APPENDIX 2 – PLANS AND IMAGES

APPENDIX 3 – CONSULTATION REPONSES – INTERNAL AND EXTERNAL

Stakeholder	Question/Comment	Response
Design	<p>HGY/2024/3386 - 312 High Road Tottenham London N15 4BN</p> <p>Refurbishment, conversion, and extension of the existing building, along with the construction of two new single storey buildings to the rear. Commercial use on part of the ground floor and self-contained residential uses on upper floors to provide short stay emergency accommodation.</p> <p>This proposal is for the refurbishment and extension of no. 312 High Road, Tottenham, to provide fifty-two bed-sitter units for emergency accommodation for the homeless, run by a private company for profit, but with the clients to be housed nominated and (it is assumed) paid for by local authorities.</p> <p>Site Location and Context</p> <p>The site is an existing property on the east side of the High Road, facing the west side of Tottenham Green, just north of the east side of The Green. Its immediate neighbour to the south is a garden in front of the High Cross United Reformed Church, the garden having been formed by the demolition of the old, Victorian gothic church following the construction of

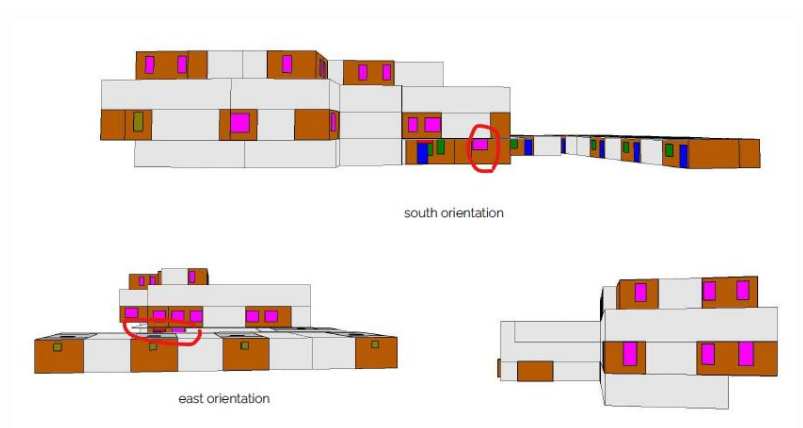
The submitted overheating strategy is not acceptable; a revised strategy is required to address the comments in the actions section.

- The proposed shading strategy is unclear. The proposed elevations have indicated the provision of brise-soleils; however, it is unclear if they have been modelled in the OH assessment. Please identify the dwellings units provided with external shading and provide the specifications.
